# UNITED STATES PATENT AND TRADEMARK OFFICE

10/772,101

Jacques Seguin

<b>Office Action Summary</b>	Application No. 10/772,101	Applicant(s) SEGUIN ET AL.	
	Examiner Ann Schillinger	Art Unit 3738

Attachment A

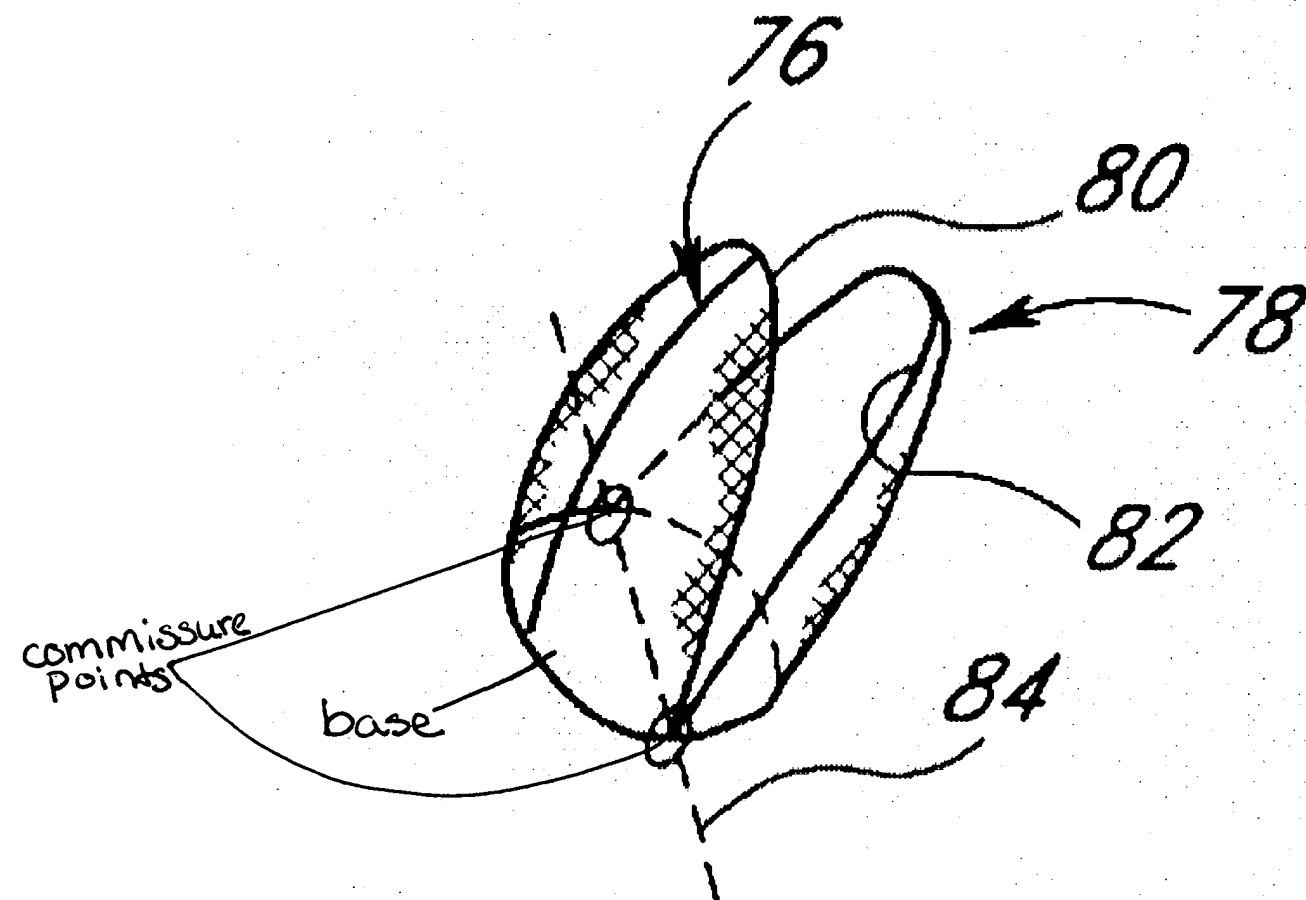
In claim 79, '637 discloses the following: a prosthetic valve assembly (40) for use in replacing a deficient native valve (30), the valve assembly comprising (col. 2, lines 55-58): a valve having a base (see attachment A), a plurality of commissure points (see attachment A), and a plurality of resilient leaflets (76, 78); a valve support (44)
